**CITY PLAN COMMISSION****THURSDAY, NOVEMBER 7, 2024****FILE NUMBER:** S245-006**SENIOR PLANNER:** Hema Sharma**LOCATION:** Haskel Avenue, south of Floyd Street**DATE FILED:** October 9, 2024**ZONING:** PD 298 (Subarea 12, Tract 2)**PD LINK:** <https://dallascityhall.com/departments/city-attorney/Articles/PDF/Article%20298.pdf>**CITY COUNCIL DISTRICT:** 14**SIZE OF REQUEST:** 0.1574-acres**APPLICANT/OWNER:** Jeff Fairey**REQUEST:** An application to create one 0.1574-acre lot from a tract of land in City Block 766 on property located on Haskel Avenue, south of Floyd Street.**SUBDIVISION HISTORY:**

**STAFF RECOMMENDATION:** The request complies with the requirements of the PD 298 (Subarea 12, Tract 2); therefore, staff recommends approval of the request subject to compliance with the following conditions:**General Conditions:**

**PRELIMINARY PLAT**

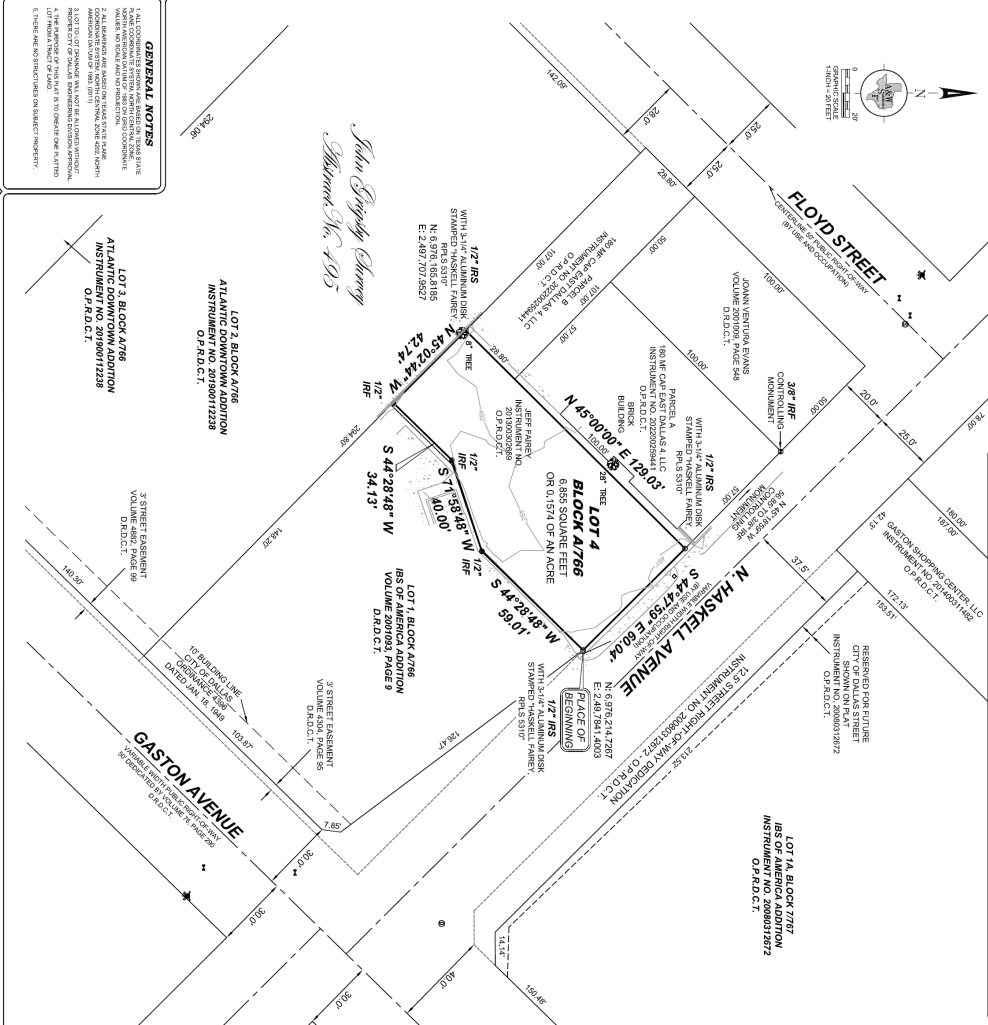
15. On the final plat, dedicate 32.5 feet of right-of-way (via fee simple) from the established center line of Haskel Avenue. *Section 51A 8.602(c)*

16. Comply with Mill Creek drainage requirements. Finish floor elevation must be 3' above nearest inlet, top of curb. 51A 8.611(d), C.9 of Mill Creek, Master Drainage Plan Study

17. Prior to final plat, submit a completed final plat checklist and all supporting documents.
18. On the final plat, show how all adjoining right-of-way was created. Section 51A-8.403(a)(1)(A)(xxii).
19. On the final plat, show recording information on all existing easements within 150 feet of the property.
20. On the final plat, show all additions or tracts of land within 150 feet of the property with recording information. Platting Guidelines.

24. On the final plat, change “N. Haskell Avenue” to “Haskell Avenue”. Section 51A-8.403(a)(1)(A)(xii).
25. On the final plat, identify the property as Lot 4 in City Block A/766.
